Project: IEEE P802.15 Working Group for Wireless Personal Area Networks (WPANs)

Submission Title: [Proposed resolution for comments on data flow processing order, w/r/t FEC and Data

Whitening, for MR-FSK PHYs]

Date Submitted: [May, 2010]

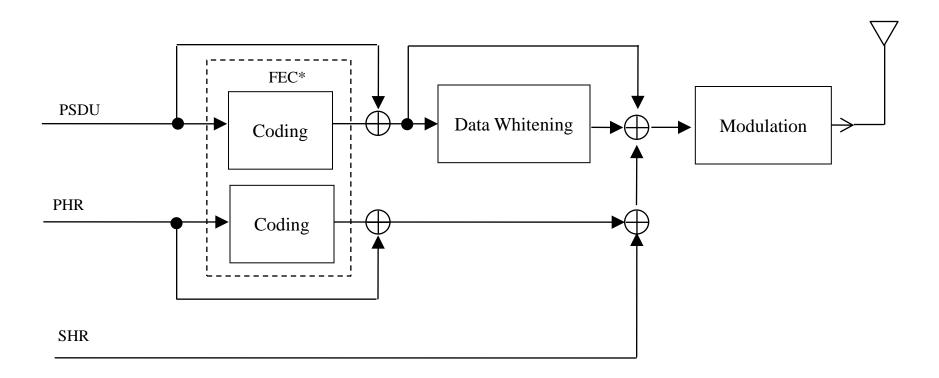
Purpose: [Proposed resolution for comments on data flow processing order, w/r/t FEC and Data Whitening, for MR-FSK PHYs. Presented to the 802.15.4g SUN Task Group for consideration.]

* When FEC is enabled, PHR and PSDU shall be coded as a single block of data, as described in < Insert correct subclause number>
